Project Name: UNIVERSITY OF CALIFORNIA, MERCED
CENTRAL PLANT/TELECOMMUNICATIONS RELIABILITY UPGRADE
Project No.: 900310

ADDENDUM NO. 3
to the
CONTRACT DOCUMENTS
September 25, 2014

1 MECHANICAL PLAN - ROOF SECTOR B
SCALE: 1/4" = 1'-0"

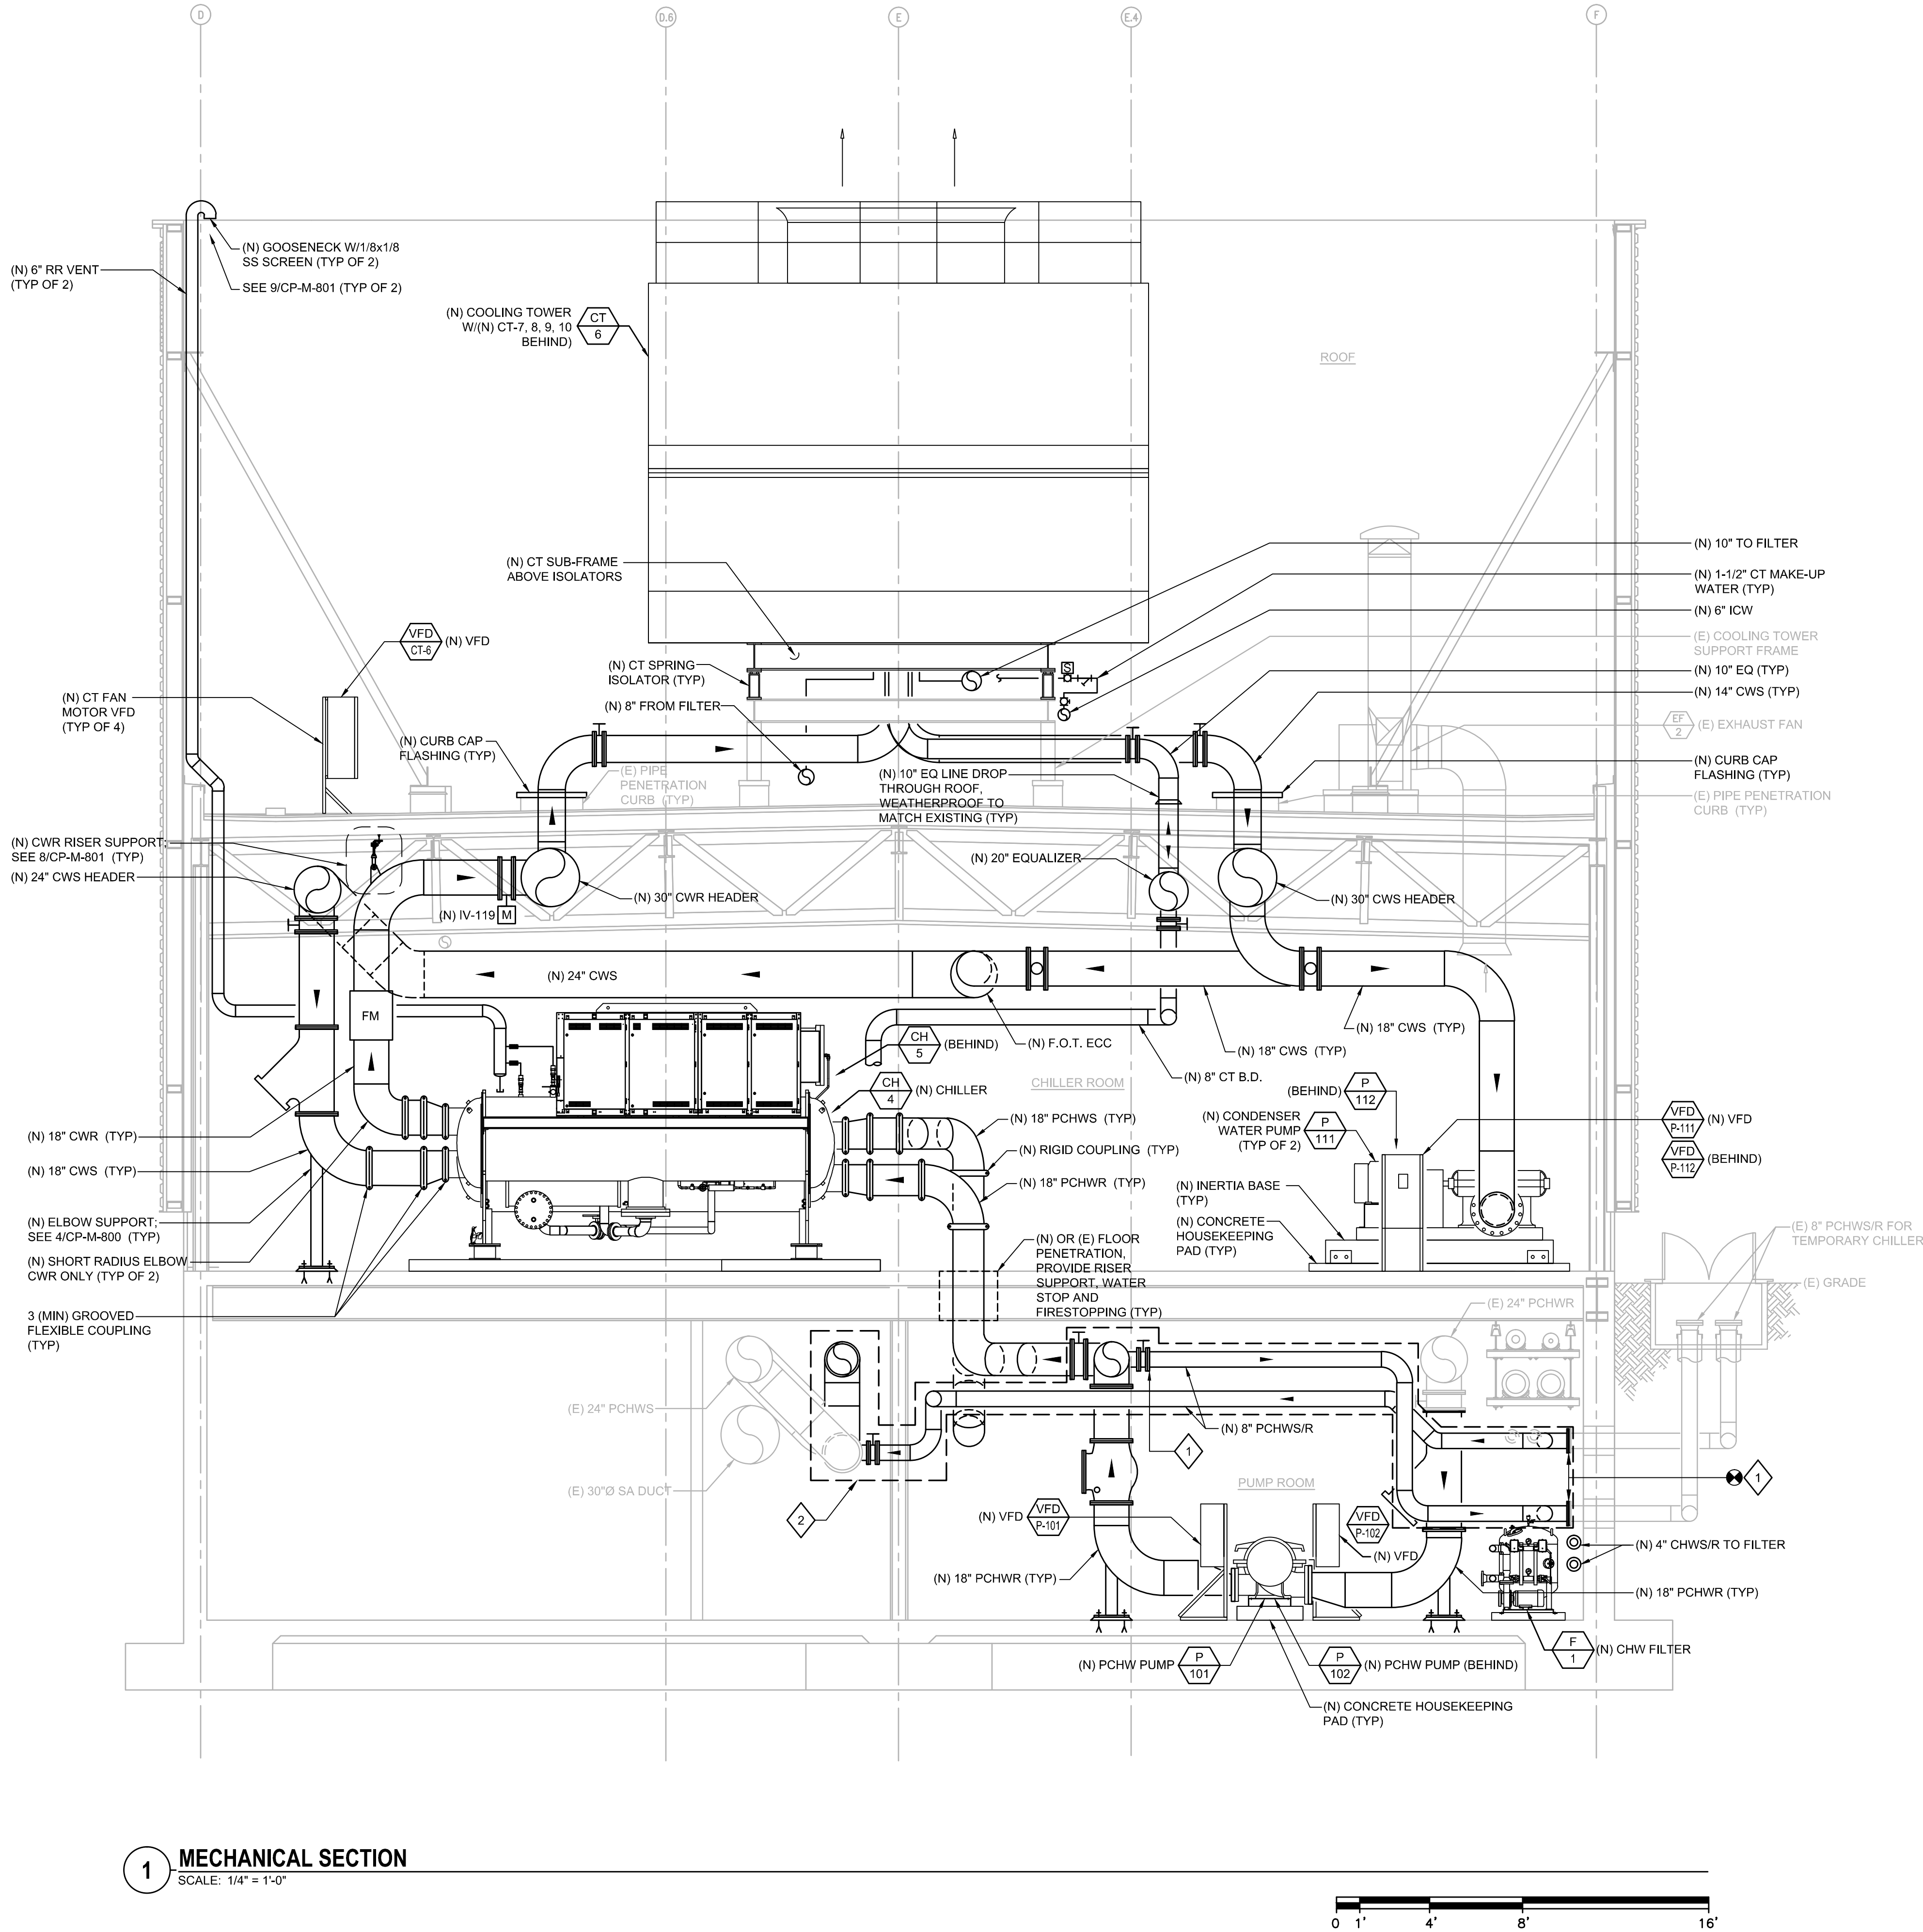
- A. Beams are not tapered. See structural framing plan and details.
19. Q. BP4 – Steel & Misc Metals: KN16/CP-M-213B Shows an aluminum stair to be constructed to Cooling tower. The Bid form Central plant item #4 states the stair is to be galvanized steel. Which material is to be provided.

21. Q. BP4 – Steel & Misc Metals: CP-M-213B Please provide the structural and flooring details related to the stair connection to the factory access platform. Would an eccentric shear plate connection with slotted holes be a permissible connection?

39. Q. BP4 – Steel & Misc Metals: What is the necessary clearance for the aluminum cross over bridge Height and width per KN17/CP-M-213B
- A. Provide 36" wide walk-over with 36"x36" landing. Limit stair rise to 8" maximum between treads. Fabricate stairs and landing height as needed to clear filter pipes plus 4" minimum.

- A. Either material is acceptable. Contractor can choose to include a pre-manufactured aluminum stair, landing, and railing in the configuration shown on the drawing, or choose to include a custom steel stair, landing, and railing.

- A. The access landing at the stair is not a factory component of the cooling tower. Metals subcontractor to provide shop drawings showing connections to existing cooling tower support frame and to roof structure as needed.

10 SCREEN WALL CAP AT CANOPY
3" = 1'-0"

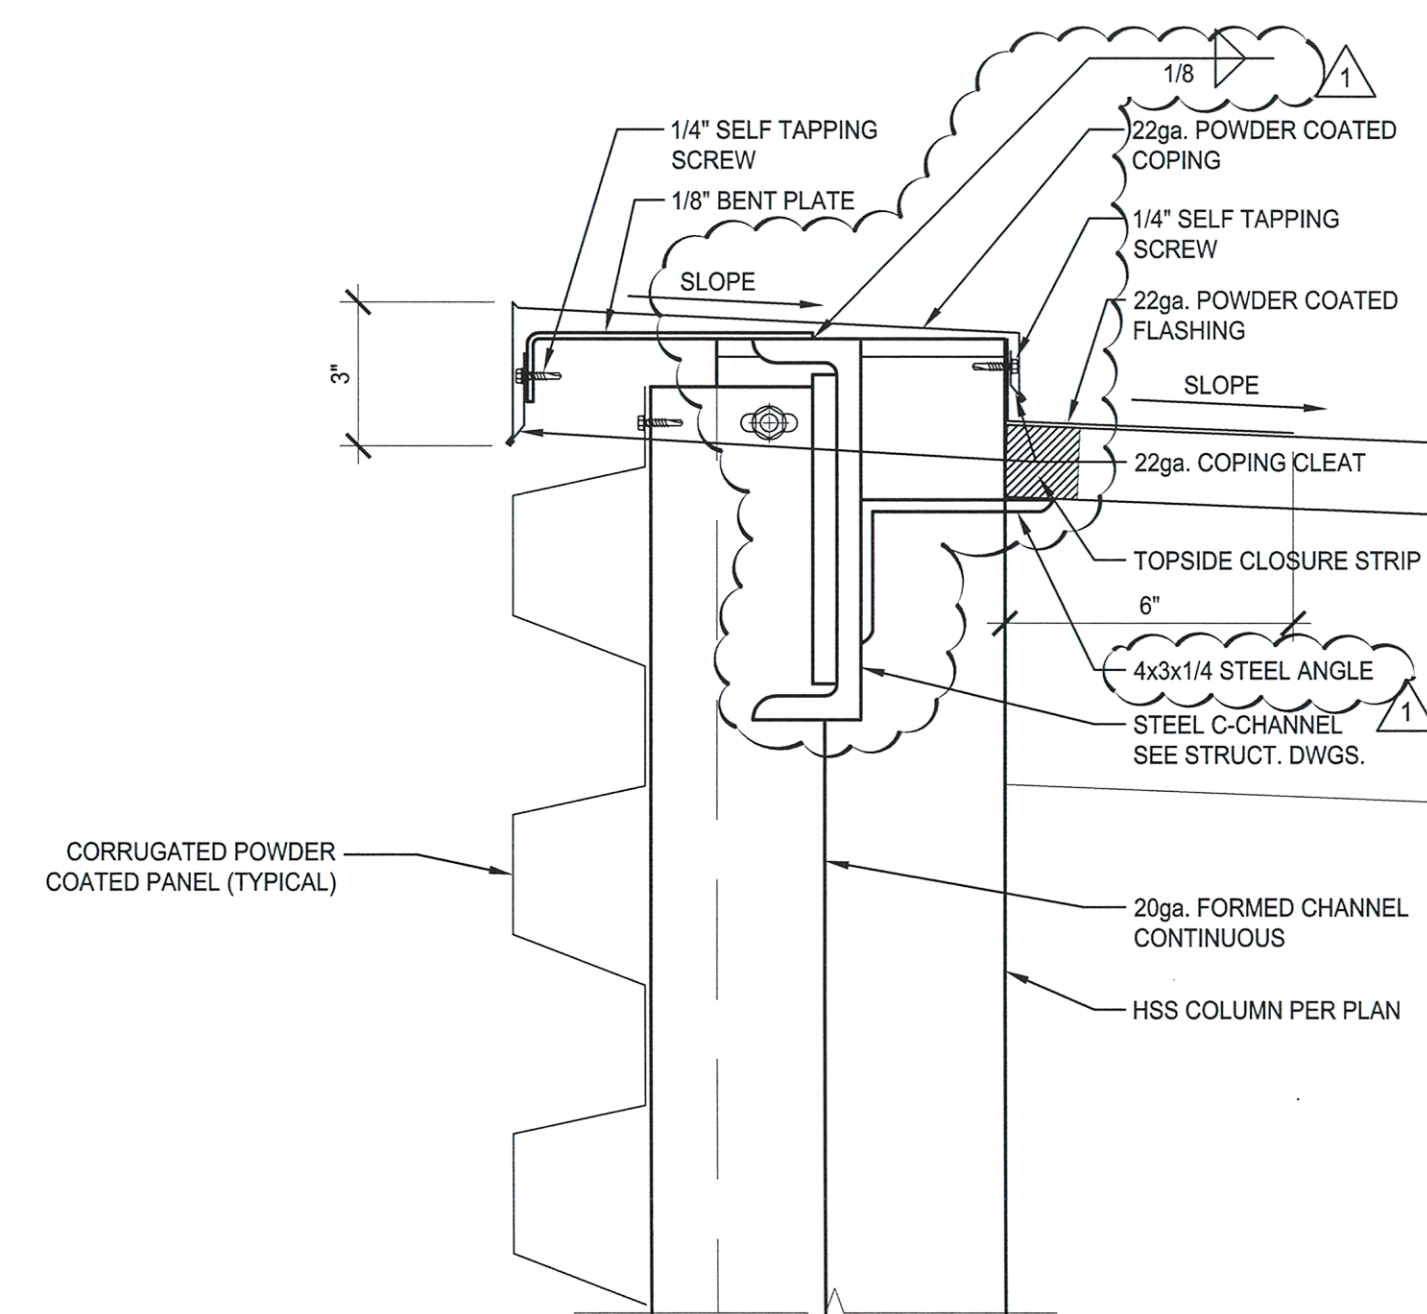
- A. Not light gauge material. See revised detail to clarify L2x2x1/8.
28. Q. BP4 – Steel & Misc Metals: 10/EP-A-800 shows a steel C channel referring to Structural drawings. No C Channel is shown on structural drawings. Please advise.

- A. C channel is used. See revised structural and architectural details.
29. Q. BP4 – Steel & Misc Metals: 2/EP-S-201F shows the 20 ga deck puddle welding to the structure. Would it be permissible to shot pin the deck with a pattern that provides an equal engineering value?

4 SCREEN WALL CAP
3" = 1'-0"

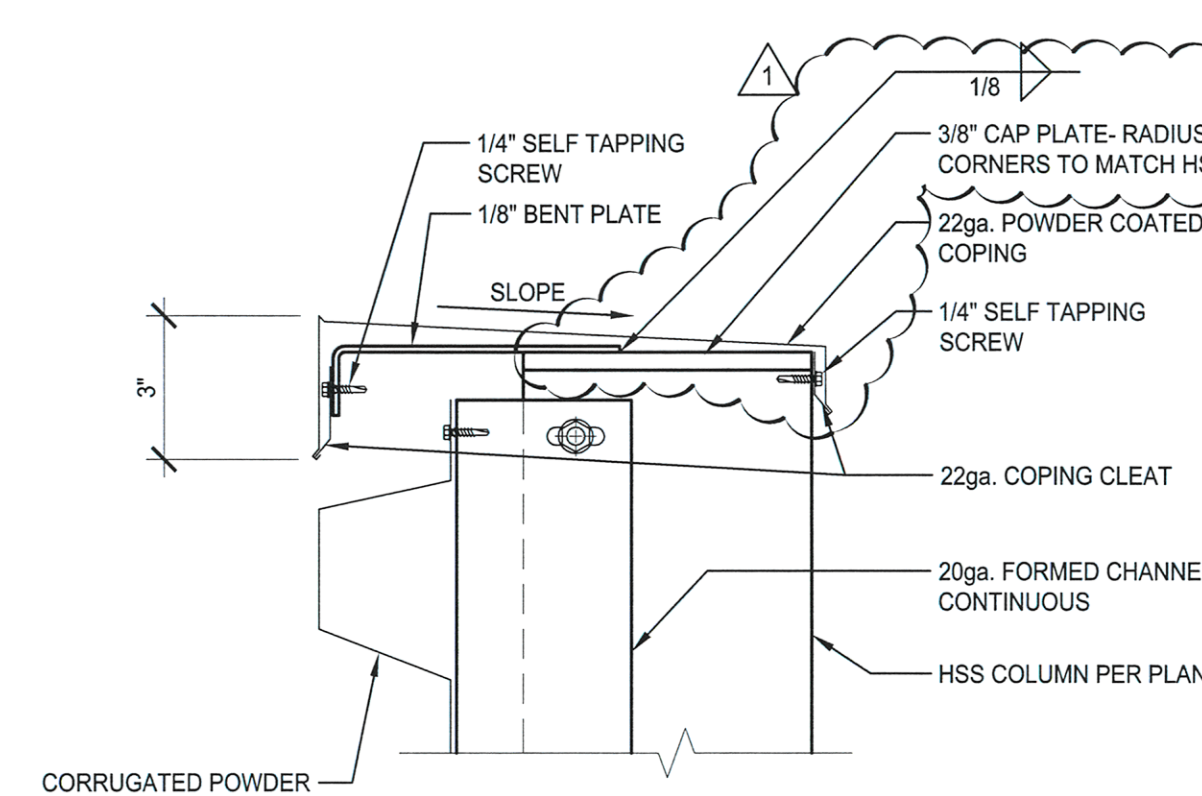
14. Q. BP4 – Steel & Misc Metals: 4,10/EP-A-800 Shows the 1/8" bent plate. It appears to be fastened to the coping cleat. Please show how this item is to be attached to the structure.

15. Q. BP4 – Steel & Misc Metals: EP-A-800 does not show a cap plate are we to assume a 1/2" cap plate per 16/EP-S-501 at each post and tube end?
- A. A cap plate per 16/EP-S-501 should be provided at each tube. See added cap plate at detail 4/EP-A-800.

- A. See added weld symbol at detail 4/EP-A-800.
